17-AMRP-0145

WASTE ENCAPSULATION AND STORAGE FACILITY (WESF) HOT CELLS A THROUGH F CLASS 1 PRIME PERMIT MODIFICATION REQUEST (PMR)

Changes to the Closure Plan are needed to extend the schedule for grout stabilization. Table H14 and Figure 18 are being revised to show the new schedule.

**WASTE ENCAPSULATION AND STORAGE FACILITY (WESF)
HOT CELLS A THROUGH F
ADDENDUM H
DANGEROUS WASTE MANAGEMENT UNIT CLOSURE PLAN
CHANGE CONTROL LOG**

Figure H13 Core Drills and Grout Addition Locations in Canyon

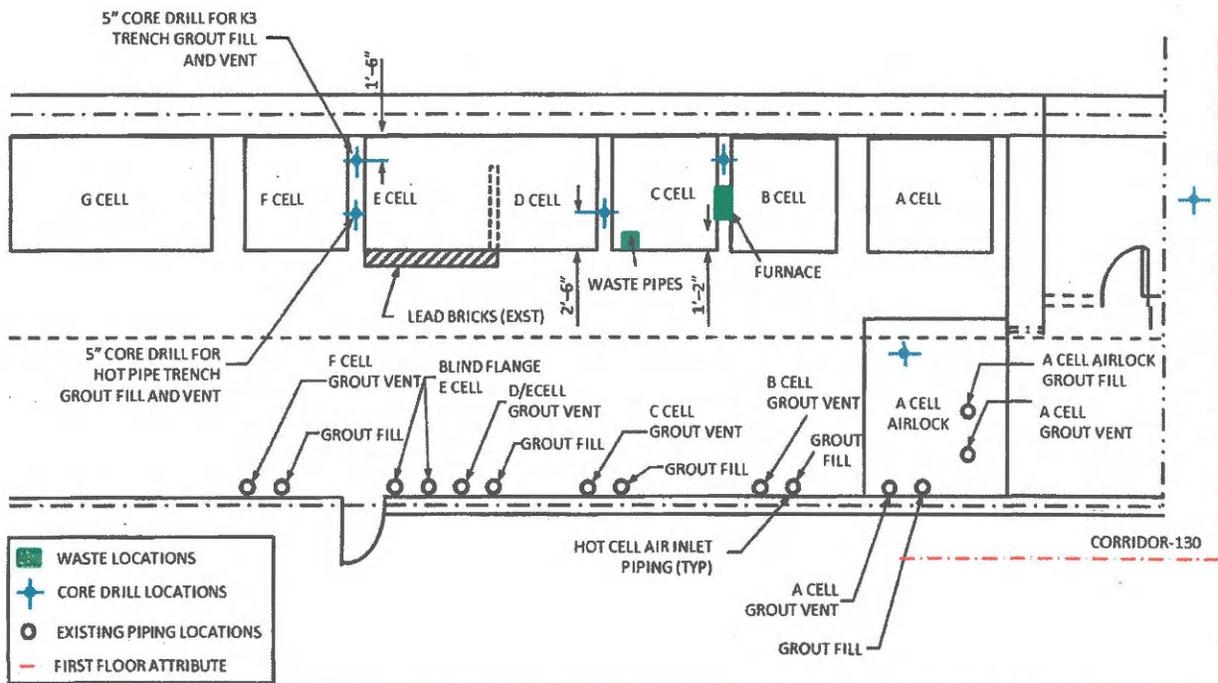
- Section H5.4, page H.44, lines 25-29 (possibly)
- Figure H13, page H.47
- Section H5.5.5, page H.48, lines 1-3
- Section H5.5.6, page H.48, lines 8-16
- Section H5.5.7, page H.48
- Table H14, page H.73
- Figure H18, page H.75
- Any other sections specifically referencing locations of core drills or duration of grout stabilization.”

| Hanford Facility RCRA Permit Modification Form | | | | |
|---|---|---------|---------|---------|
| <p><u>Description of Modification:</u></p> <p>Changes to the Closure Plan are needed to:</p> <ul style="list-style-type: none"> Address the movement of a core drill location during grout stabilization and modification made prior to stabilization. Revisions are being made to Section 5.4, 5.5.6, and Figure H13. No revision is being made to Sections 5.5.5 and 5.5.7 since activities described were not affected by the location change for the core drill. Include direction for potential unanticipated minor deviations (Section 5.13). | | | | |
